TOLEDO - LUCAS COUNTY PLAN COMMISSIONS

REF: SUP25-0023

SUBJECT: Request for a Special Use Permit for a Cultural Exhibit at 1600 Mott Avenue

- Request - Amendment to Special Use Permit, Originally Granted by Ord.143-24, for Polish Cultural Center
- Location - 1600 Mott Avenue (parcel #1627991)
- Applicant/Owner - Tom Waniewski
Polish Cultural Center Advisory Board
PO Box 291
Waterville, OH 43566
- Engineer - Troy Barman
Verdantas LLC
219 S Erie Street
Toledo, OH 43604

SITE PLAN

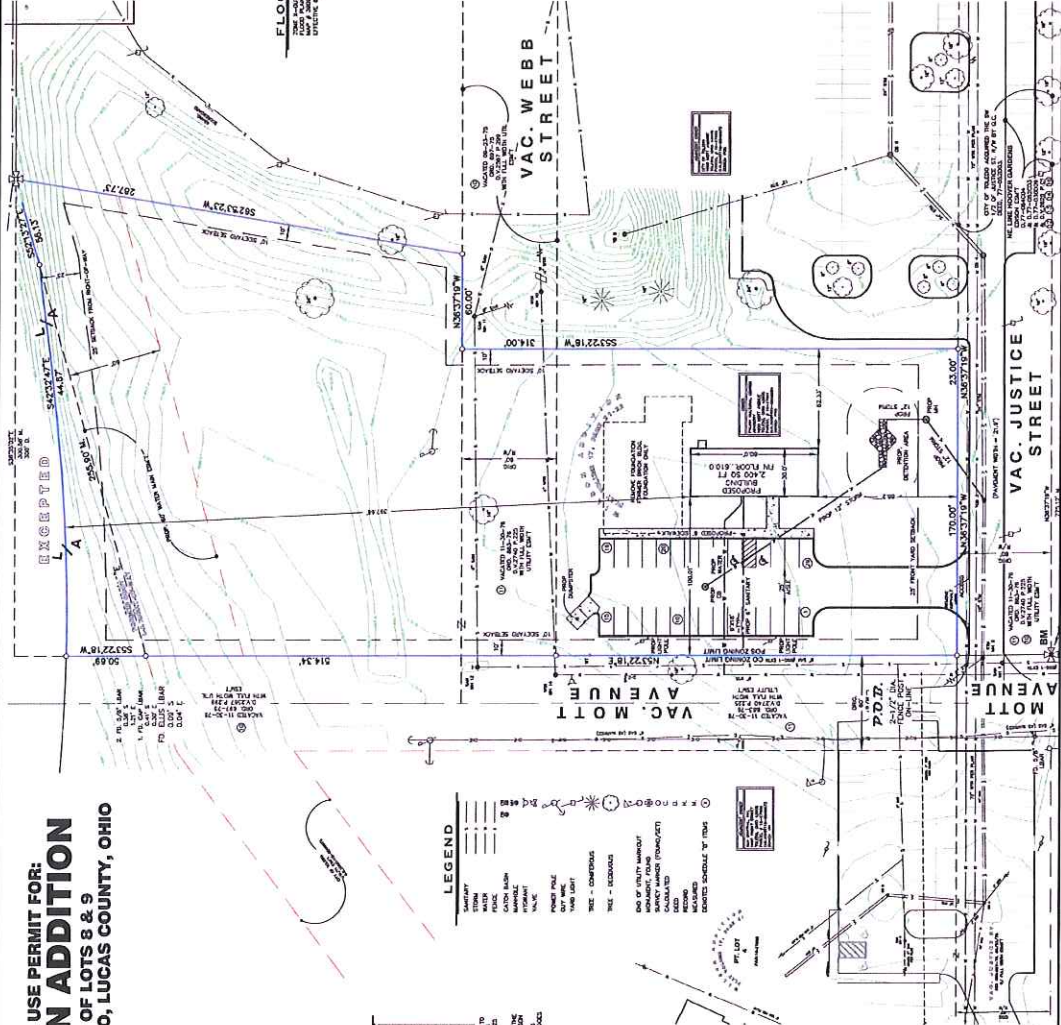
Pursuant to TMC§1107.0300 - *Off-Street Parking Schedule "A"*, Cultural Exhibits require one (1) parking space per 1,000 square feet. The proposed building area of 2,400 sq ft., requires a minimum of three (3) parking spaces. The site plan proposes twenty-six (26) spaces, exceeding the maximum allowed of five (5) spaces. Adjacent to the site is the Ravine Park II parking lot containing an estimate of three-hundred and four (304) parking spaces. An alternative parking plan shall be submitted to justify the need of excess parking pursuant to TMC§1107.400 B.

Bicycle parking is required pursuant to Off-Street Parking Schedule "A" (TMC§1107.0300). A minimum of one (1) bicycle space shall be provided per ten (10) automobile parking spaces. The parking lots contain a total of 26 spaces, requiring at least three (3) bicycle parking spaces. The submitted site plan does not depict any bicycle parking; this omission shall be addressed in revised site plans and is listed as a condition of approval.

Furthermore, the POS zoning distinction does not trigger any screening requirements between abutting properties as per TMC§1108.0203 – *Buffer and Screening Requirements*. However, the site plan depicts a greenbelt along the southwestern edge of the parcel to screen the proposed stormwater detention basin. This greenbelt is comprised of five (5) trees and a continuous shrub row and is acceptable as depicted. Screening comprised of five-foot (5') evergreens is also depicted surrounding three (3) sides of the proposed dumpster. These plantings will be accompanied by a fence or wall structure surrounding all four (4) sides of the dumpster, as required by TMC§1108.0203(G), and shall be shown on a revised plan.

Interior parking lot plantings, as specified in TMC§1108.0204, must provide two (2) canopy trees and six (6) shrubs for each ten (10) parking spaces. With twenty-six (26) proposed spaces, the required interior planting area must be comprised of at least six (6) trees and sixteen (16) shrubs. The current site plan depicts six (6) trees and twenty-four (24) shrubs and is acceptable as depicted. In addition, perimeter parking lot plantings are required to visually screen parking facilities from view of Residential districts and public right-of-ways. A minimum of at least one (1) canopy tree must be provided for each thirty (30) linear feet, plus a continuous shrub with a minimum height of eighteen (18) inches. Plans depict adequate perimeter parking plantings to screen the parking lot from the Residential district to the southwest.

26. Bicycle parking is required per TMC 1107 .0900.
27. Accessible parking signage must be posted directly in front of the parking space at a height of no less than 60" and no more than 72" above pavement level per TMC 1107.1704.
28. If one does not already exist, a cross access agreement is required with the adjacent property owner to the Southwest.
29. Sidewalk is required along the drive way access, connecting the building sidewalk to Mott Street per TMC1107.1300.

30. Staff requests connecting sidewalks to be installed as proposed in SUP-12003-24, and which was approved by Ord. 143-23.
31. Per TMC§1107.0600 – Off Street Parking Schedule “A,” the minimum number of parking spaces required for a cultural exhibit is 1 per 1,000 square feet of floor area. Applicant is required to provide a minimum of three (3) spaces for 2,400 square feet. Pursuant to TMC§1107.0302 parking shall not exceed a maximum of 150% of the minimum, except through an approved alternative parking plan. **Site plans propose twenty-six (26) spaces, exceeding the maximum allowed. An alternative parking plan shall be submitted pursuant to TMC1107.0400.**

33. Per TMC§1107.0400, Off-Street Parking Schedule “A” requires one (1) bicycle parking slot per ten (10) parking spaces. **Not acceptable as depicted on site plan. A bike rack with a minimum of three (3) slots shall be provided on revised plan.**

- a. Dumpster location(s) shall be clearly defined, have a concrete pad and be screened on all four sides by any combination of evergreen plantings, fence, or wall structure and shall not be located in any required setbacks or the public right-of-way as stated in TMC§1361.10(b)(10) of the Building Code. **Not acceptable as depicted. The plantings depicted on the site plan will be accompanied by a fence or wall structure surrounding all four (4) sides of the dumpster, as required by TMC§1108.0203(G) and shall be depicted on a revised site plan.**

- g. If the site is ½ acre or larger, landscaped areas must be irrigated as necessary to maintain required plant materials in good and healthy condition. Irrigation plans must be submitted with development plans and must contain all construction details; **Not acceptable as depicted; applicant shall provide irrigation plans for the site as it is larger than ½ acre.**

PROPOSED ELEVATIONS

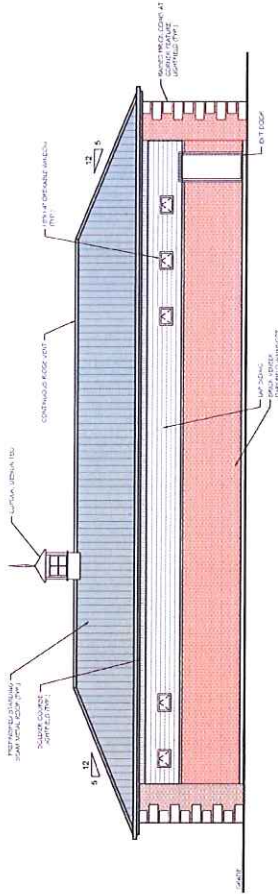
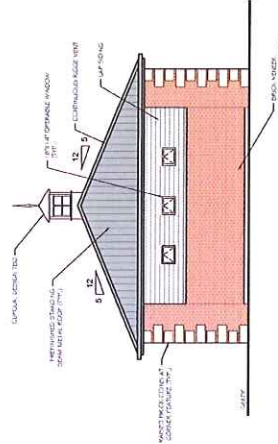
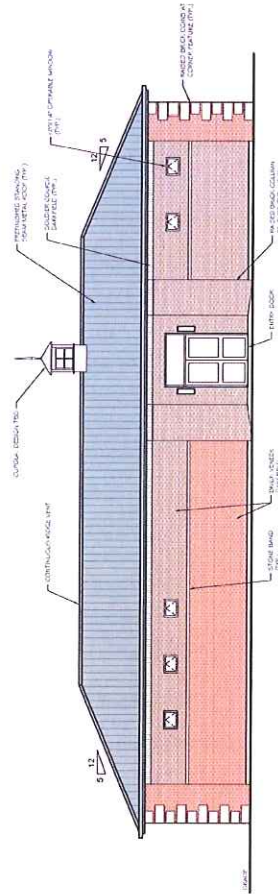
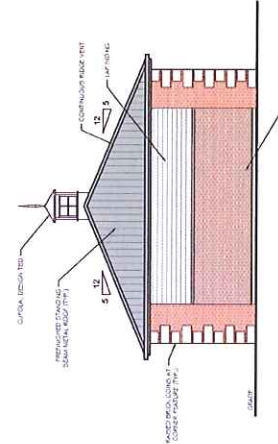
The proposed building elevations are comprised of brick veneer and wood-lap siding. The proposed brick is classified as "predominant materials" and the wood-lap siding is classified as an "accent material" per TMC§1109.0500 – *Building Façade Materials and Color*. In order to adhere to this code section, predominant materials must consist of at least 80% of each elevation and only up to 20% of each elevation may be comprised of accent materials.

The south elevation meets these thresholds however, the remaining three (3) elevations do not meet the predominant material threshold and exceeds the accent materials permitted. Revised elevations must depict material types and percentages that are in conformance with TMC§1109.0500, and is listed as a condition of approval.

- j. The location, lighting, and size of any signs.
37. Any future proposed signage must meet the requirements of *TMC§1113 - Signs*.
38. Building elevations shall be of quality materials as stated in TMC§1109.0500. **Not acceptable as depicted, as accent materials proposed surpass 20% of each elevation. Revised elevations must be submitted depicting material types and percentages that are in conformance with TMC§1109.0500.**
